PROJECT:
Lathbury Road, Manchester

DESCRIPTION:
Schedules and Site Plan

PURPOSE OF ISSUE:
Planning

JOB NO:	STATUS CODE:	DRAWING NO:	REV
3788	S2	105	24

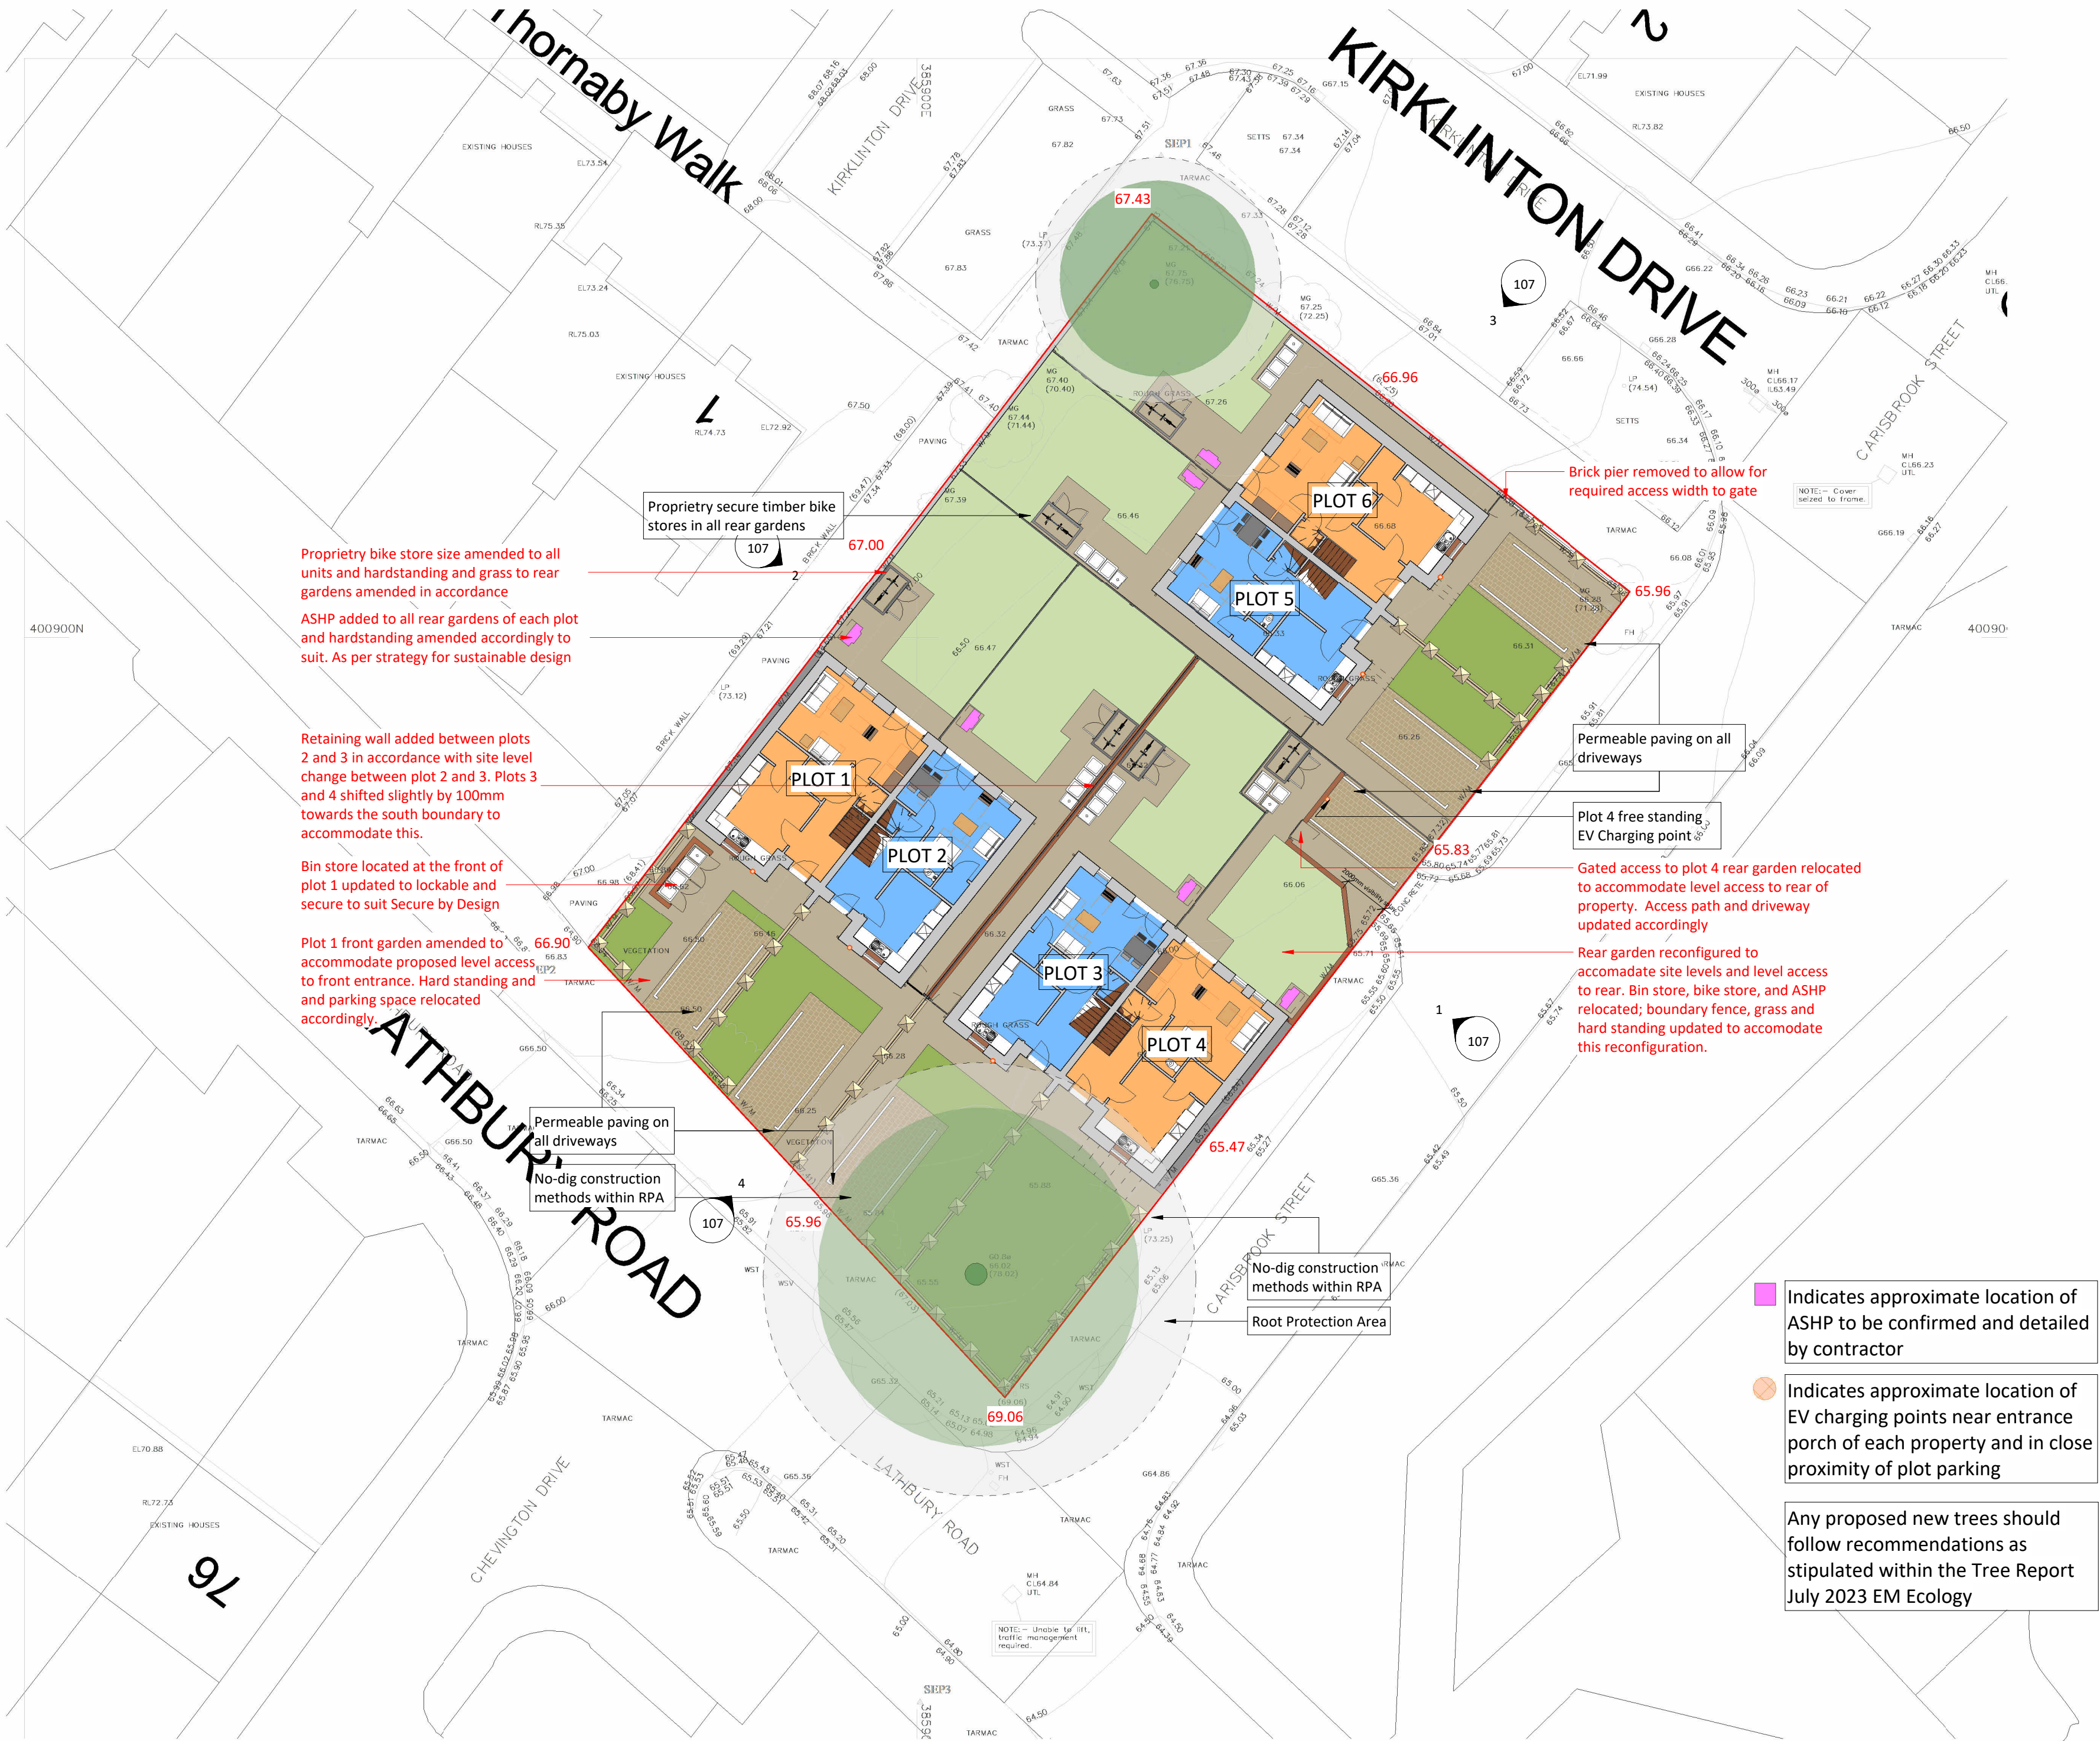
*These amendments are a result of;
- Secure by Design
- Visual appearance and Design requirements (in line with Employers Requirements)
- Sustainable Design
- Accommodation of Existing Site Levels

24	19.02.25	HG	Red annotations added to drawings to denote the changes made to the design as part of the NMA submission as requested by MCC.
23	11.02.25	HG	Drawing revised in line with client comments to determine levels and encapsulate all amendments for NMA submission.
22	15.01.25	HG	Site Plan amended in line with levels information and issued as DWG.
21	25.11.24	HG	Drawing updated as part of NMA submission and to discharge conditions.
20	15.12.23	JW	Affordable rent note added to schedule of accommodation.
19	13.12.23	JW	Bin store to plot 1 updated.
18	13.12.23	JW	Plot 1 bin store moved to front of property and boundary treatment updated.
17	08.12.23	JW	Drawing package updated to show increased wall depth with 195mm reveal.
16	04.12.23	JW	Boundary shown between plot 2 and 3 following planning officers comments.
15	24.11.23	JW	ASHP shown indicatively, window reveal updated to show 195mm reveal and boundary updated following planning officers comments.
